SCREENING OUT COUPLED THERMAL-HYDROLOGIC-CHEMICAL EFFECTS (RESPONSE TO ENFE 4.03 AND GEN 1.01 (COMMENTS 35 AND 37))

This appendix provides a response for Key Technical Issue (KTI) agreement Evolution of the Near-Field Environment (ENFE) 4.03 and general agreement (GEN) 1.01, comments 35 and 37. These KTI agreements relate to providing the technical basis for the screening of thermal-hydrologic-chemical effects on colloids and colloid transport.

This appendix provides a response for Key Technical Issue (KTI) agreement Total System Performance Assessment and Integration (TSPAI) 3.30 and general agreement (GEN) 1.01, comments 43 and 46. These agreements relate to providing the technical basis for concentrations of colloids available for reversible attachment.

This appendix provides a response for Key Technical Issue (KTI) agreement Radionuclide Transport (RT) 3.07 and general agreement (GEN) 1.01, comments 35, 43 and 46. These KTI agreements relate to providing sensitivity studies for colloid transport parameters and models.

Figure C-2. Thermal-Hydrologic-Chemical Simulation (Tptpmn Model): Time Profiles of the Modeled pH of Fracture Water at Three Drift-Wall Locations under Heating (Heat) and Nonheating (Ambient) Conditions for the Extended (E) and Base-Case (B) Geochemical Systems

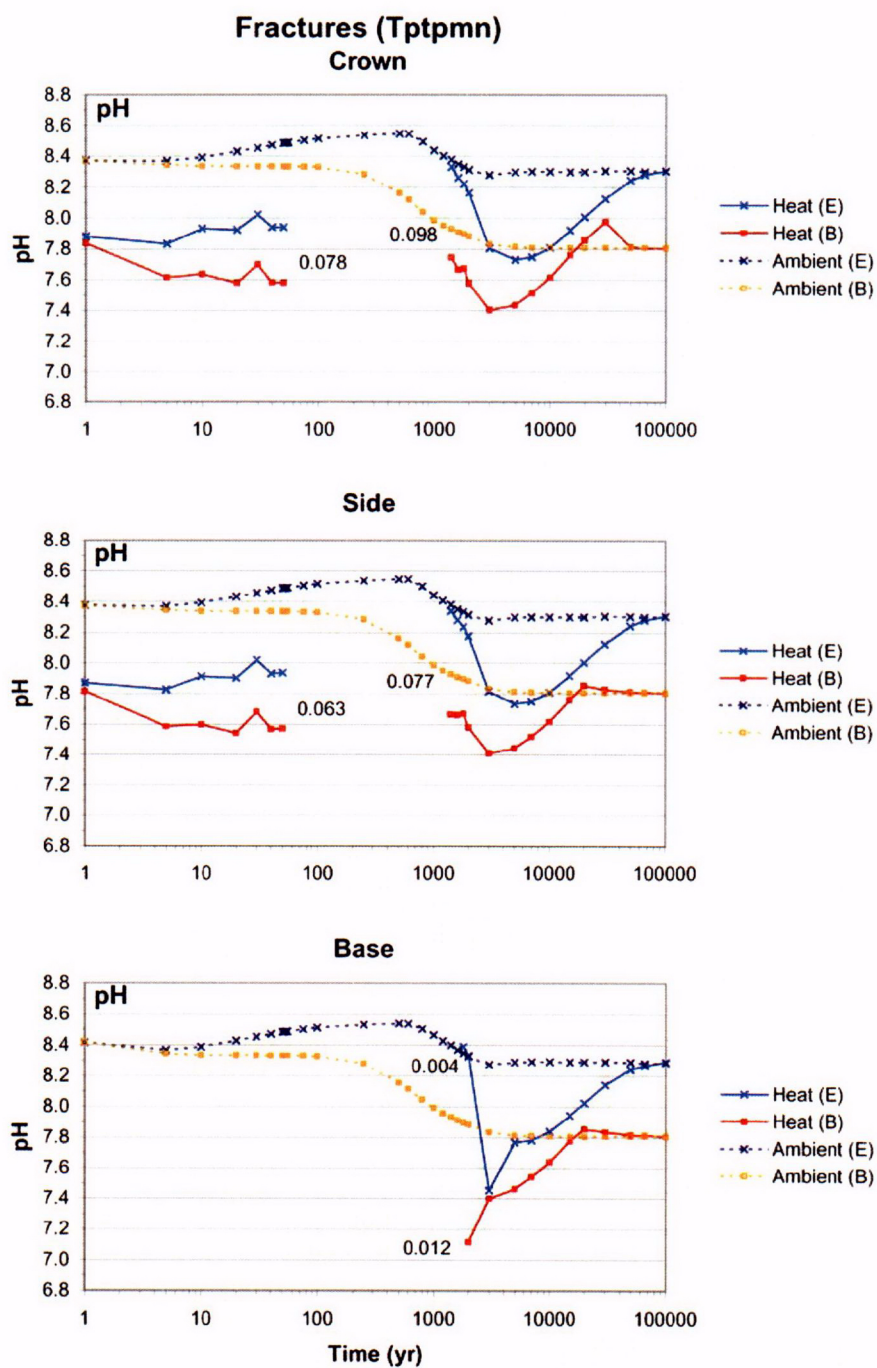
The discussion of THC effects on UZ transport does not address chemical effects of the repository. This concern is related to KTI agreements ENFE 4.03 and ENFE 4.06, and TSPAI FEPs item J-8.

The thermal-hydrologic-chemical model simulations have been performed for both the base case and the extended case and for both Tptpmn and Tptpll geologic formations (BSC 2003a). The extended case includes the major solid phases (minerals and glass) encountered in geologic units at Yucca Mountain, together with a range of possible reaction product minerals, CO_2 gas, and the aqueous species necessary to include these solid phases and the pore-water composition within the thermal-hydrologic-chemical model. The base case is a subset of the extended case excluding aluminum silicate minerals, which form or dissolve much less easily than minerals such as calcite or gypsum. The results for the Tptpmn rock unit are shown in Figures C-2 and C-3. The pH in fracture waters varies within 7.4 to 8.6 but still remain within a neutral to mildly basic range over the 10,000-year regulatory time period (Figure C-2), and thus its effect on colloid stability is expected to be negligible. The concentrations of soluble components (e.g., Na and Cl) and therefore the ionic strength in the waters are predicted to increase over the time period of thermal event (Figure C-4), which will reduce colloid stability. The THC effect may also change the transport properties of rock. However, Figure C-3 shows that this change is small and can be negligible for colloid transport.

Figure D-3. Cumulative Distribution Function of Uncertainty in Groundwater Colloid Concentrations

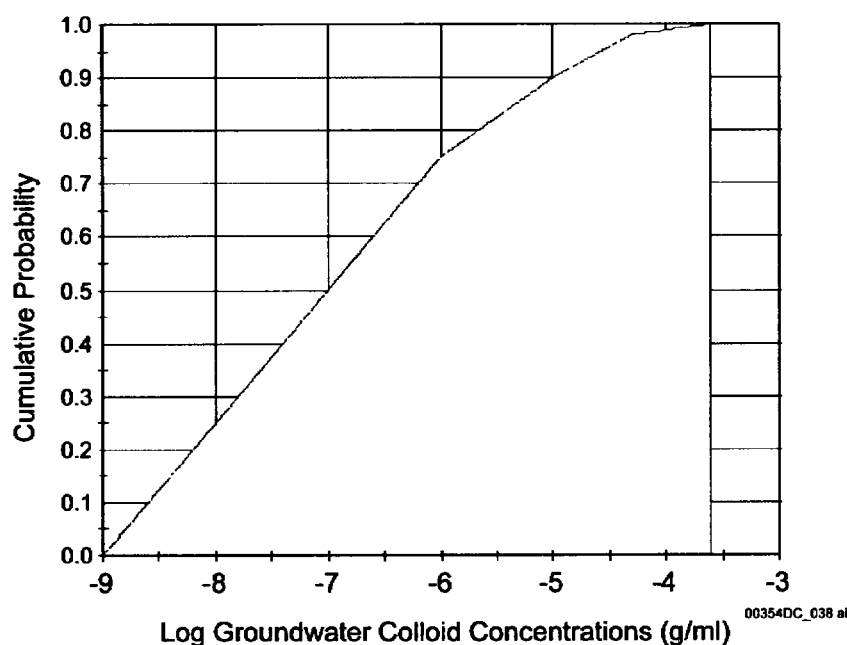
Provide the technical basis for the contrasting concentrations of colloids available for reversible attachment in the engineered barrier system and the saturated zone. Sensitivity analyses planned in response to RT Agreement 3.07 should address the effect of colloid concentration on K_c . Update, as necessary, the K_c parameter as new data become available from the Yucca Mountain region ...

Concentration of Reversible Colloids in the Saturated Zone—Radionuclides that are reversibly sorbed onto colloids are modeled to be temporarily attached to the surface of colloids. Thus, these radionuclides are available for dissolution in the aqueous phase and their transport characteristics are a combination of the transport characteristics of solute and colloids. The saturated zone transport simulations of radionuclides that are reversibly attached to colloids are conducted for radioisotopes of plutonium, americium, thorium, protactinium, and cesium (BSC 2003b). (Note that a major fraction of plutonium and americium is transported as irreversibly sorbed onto colloids.)

Figure F-2. Uncertainty in the Statistical Fit for the Diffusion Coefficient

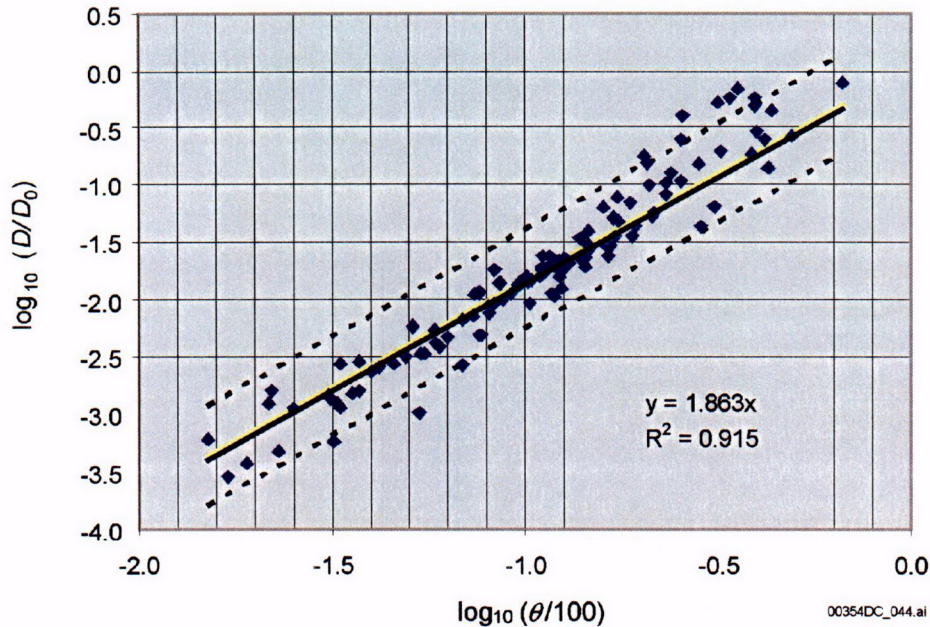
Provide an uncertainty analysis of the diffusion coefficient governing transport of dissolved and colloidal radionuclides through the invert. The analysis should include uncertainty in the modeled invert saturation (ENG4.4.1). DOE will provide an uncertainty analysis of the diffusion coefficient governing transport of dissolved and colloidal radionuclides through the invert. The analysis will include uncertainty in the modeled invert saturation. The uncertainty analysis will be documented in the EBS Radionuclide Transport Abstraction AMR (ANL-WIS-PA-000001) expected to be available to NRC in FY 2003.

The discussion of uncertainty in the saturation level of the invert does not consider the possibility of higher saturation. This comment is related to KTI agreement TSPAI 3.17.

The diffusion coefficient for dissolved species has been determined specifically for crushed tuff invert materials as a function of volumetric moisture content (m^3 water/ m^3 bulk rock), using electric conductivity measurements (BSC 2003). Figure F-2 presents the uncertainty in the statistical fit for the diffusion coefficient.
